## **COMMITTEE OF THE WHOLE JUNE 21, 2004**

### **ZONING BY-LAW AMENDMENT FILE Z.02.084 DRAFT PLAN OF SUBDIVISION FILE 19T-02V10 1275620 ONTARIO INC. REPORT P.2004.15**

### **DRAFT PLAN OF SUBDIVISION 19T-02V10 {1275620 ONTARIO INC.} {LOT 17, CONCESSION 3}, CITY OF VAUGHAN**

POTENTIAL RECONFIGURATION OF BLOCKS 48 - 59  
TO ACCOMMODATE RED-LINE CHANGES AND  
CREATE FULL LOTS WITH ABUTTING BLOCKS  
IN DRAFT PLAN 19T-00V19

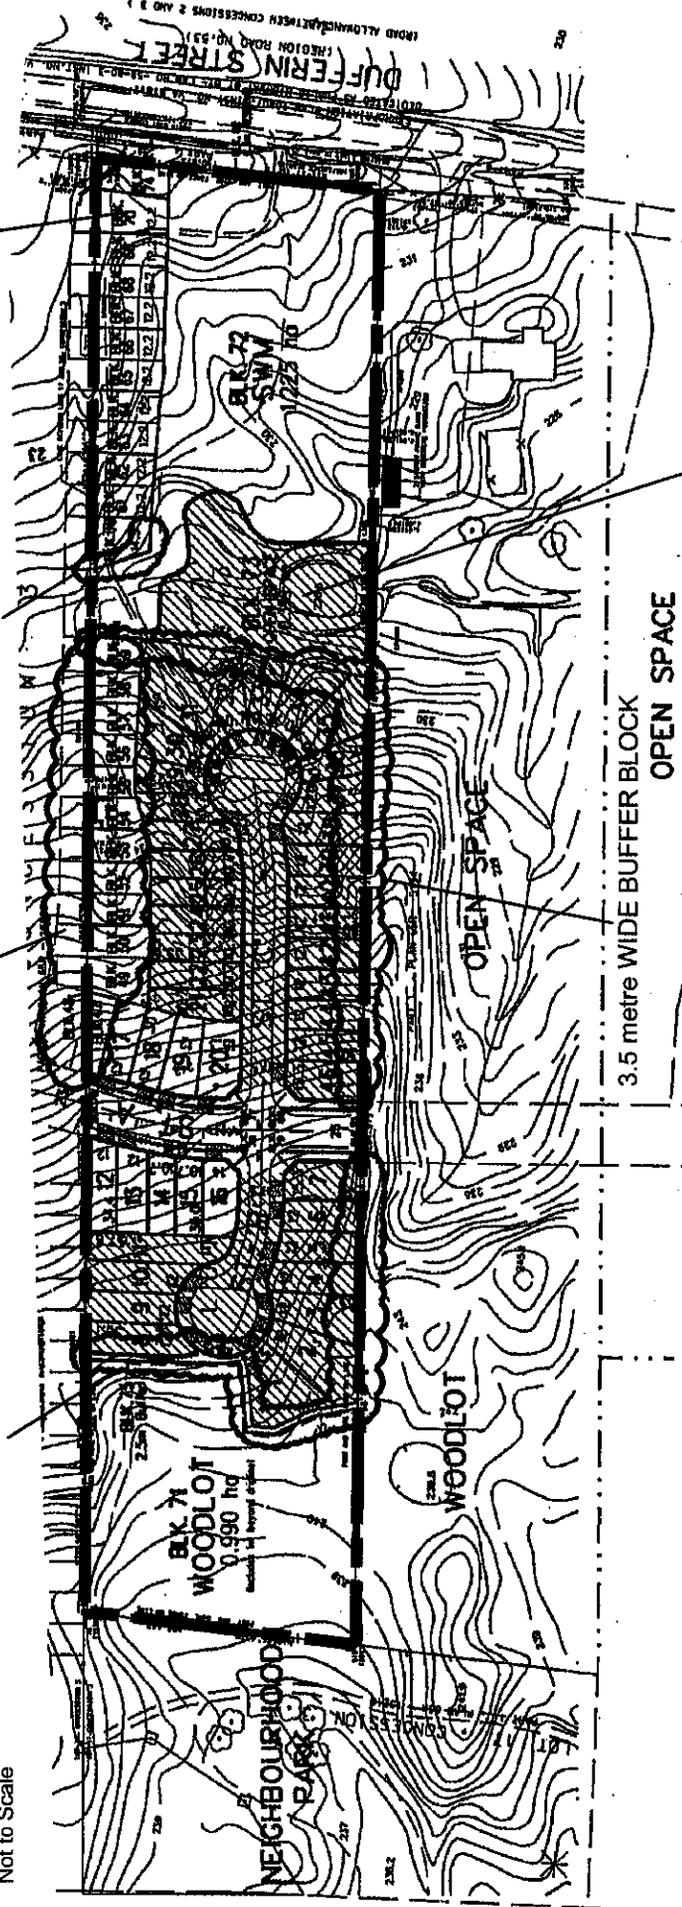
Planning Department and Toronto and Region Conservation Authority (TRCA) Staff have identified the need for additional buffer blocks to be included in the proposed draft plan of subdivision including: a 3.5 metre buffer block adjacent to the woodlot (block 71) abutting lots 1, 2 and 8; a 3.5 metre buffer block adjacent to the open space (Block 73) and the open space on the lands immediately south (non-participating landowner) abutting lots 2 to 7 inclusive, 31 to 46 inclusive and 59 and 60. The TRCA has further identified that demarcation of Block 73 (Open Space) does not coincide with the staked and surveyed limits of the block and that the storm water management block encroaches into the valley. The applicant has been redlined to incorporate these changes.

The red-lined changes may result in the need to reconfigure Blocks 48 to 59 on the plan in order to achieve full lots with the corresponding blocks in draft plan of subdivision 19T-00V19 (Arband Investments Ltd.). The plan has been red-lined and a condition of approval included to facilitate the reconfiguration of these blocks, if necessary.

- b) the draft plan of subdivision be red-lined to provide:
    - a 3.5m buffer for the lots adjacent to Lots 1 to 7 inclusive, 8, 31 to 46 inclusive;

- the reconfiguration of Block 73 (Open Space) to conform to the survey prepared by Schaeffer & Dzaldov Limited (October 2003);
    - a separate community entry block be identified along Dufferin Street for landscaping purposes as shown on the approved Block 18 Plan; and,

- the potential reconfiguration of Blocks 47 to 59 inclusive, if necessary, to accommodate the proposed red-line changes, and the completion of full lots with the draft plan of subdivision to the north (19T-00V19 – Arband Investments Ltd.).
